Doc Ref: **2751**

**Land Adj Monet Lodge
Cavendish Road
West Didsbury
Manchester
M20 1JG**

Drainage Condition Report

Project Title Drainage Condition Report – Monet Lodge, Didsbury, Manchester, M20 1JG
Project No 2751
Date 19th December 2022

- 2751 100 – Drainage GA

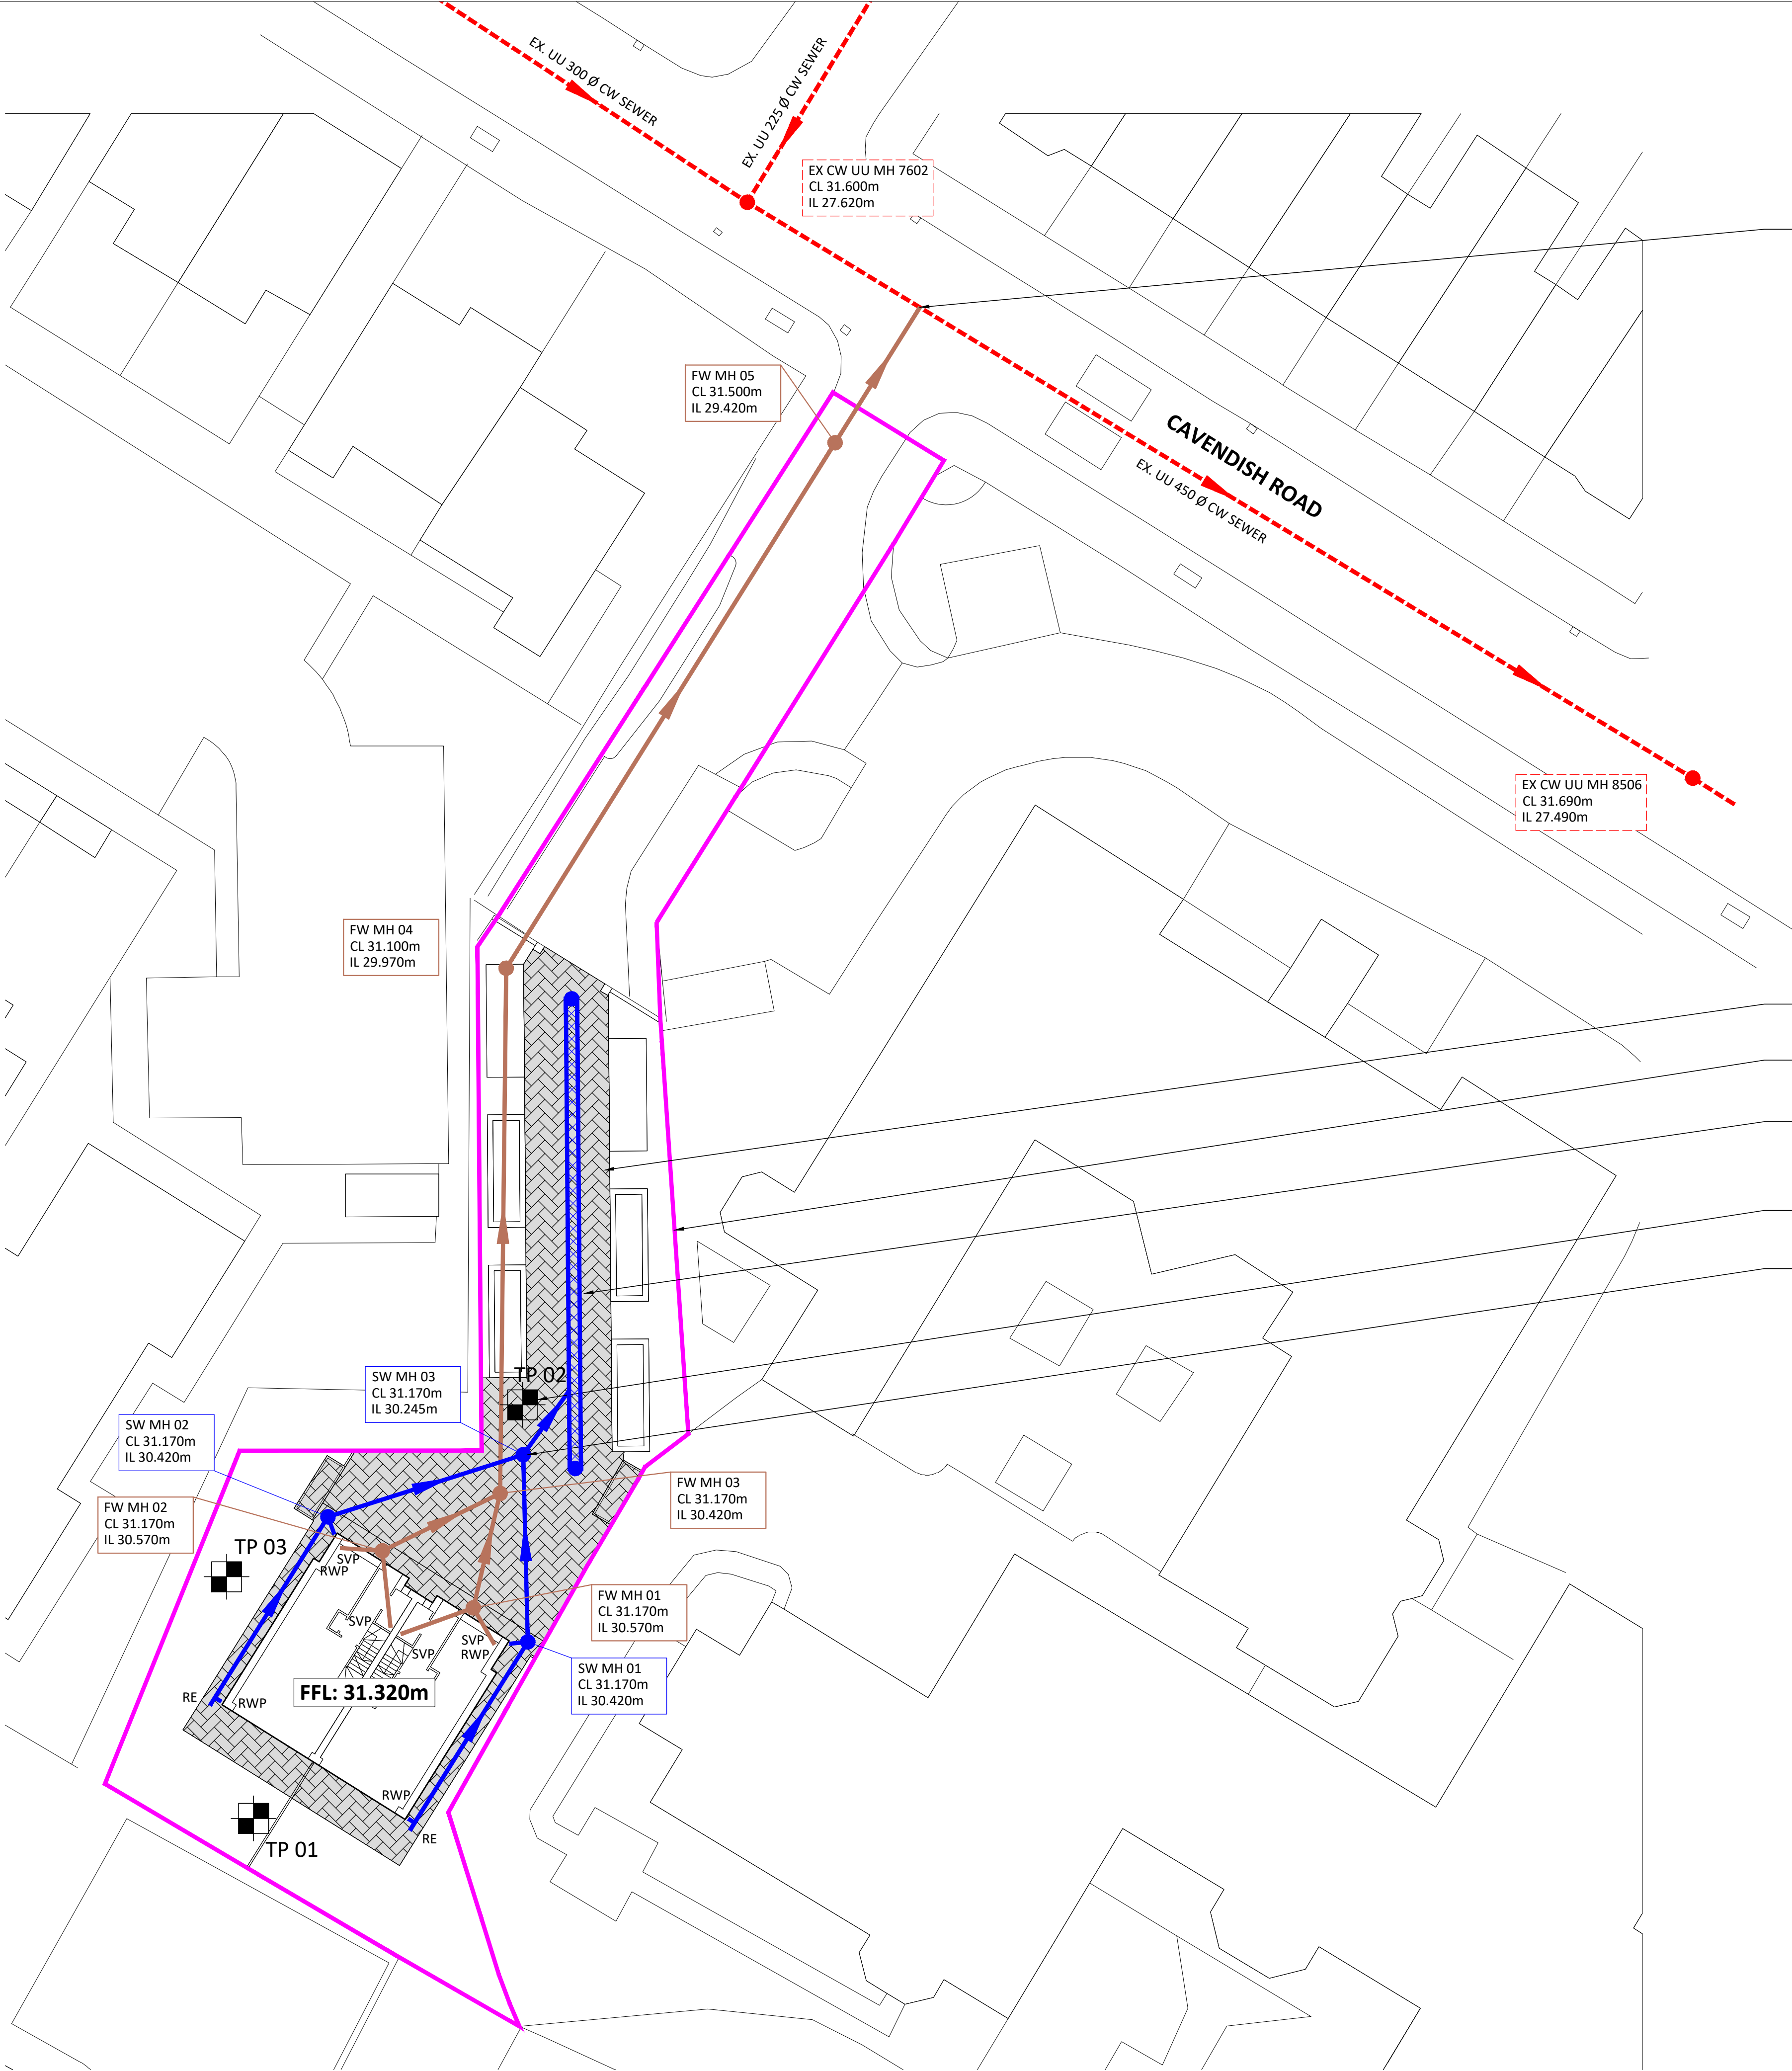
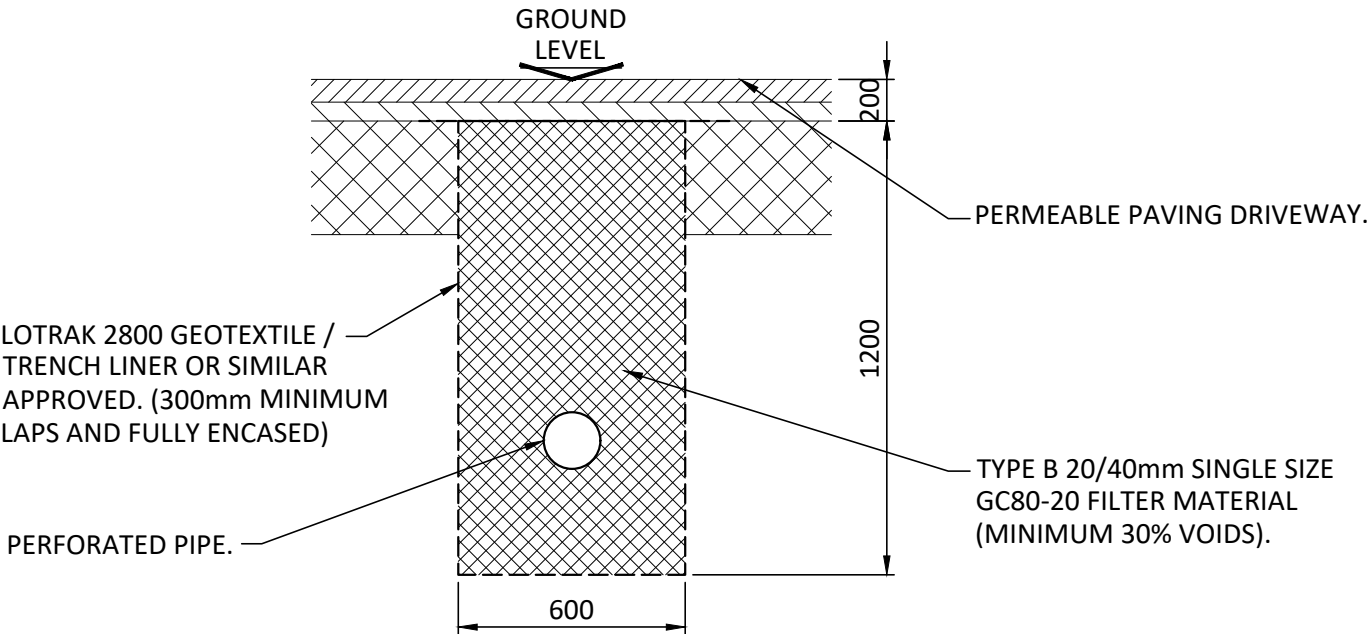
2. *Surface water drainage layout including discharge points, proposed attenuation (up to a 1 in 100 year including 40% climate change allowance) and proposed overland flow routes for extreme events which shall include a 5m easement for soakaways if infiltration is feasible.*

Refer to the drainage GA in Appendix A and the hydraulic calculations in Appendix B. This has confirmed no flooding for the 100yr + 40% peak storm event from the proposed infiltration trench. A 5m easement from the infiltration trench can be achieved.
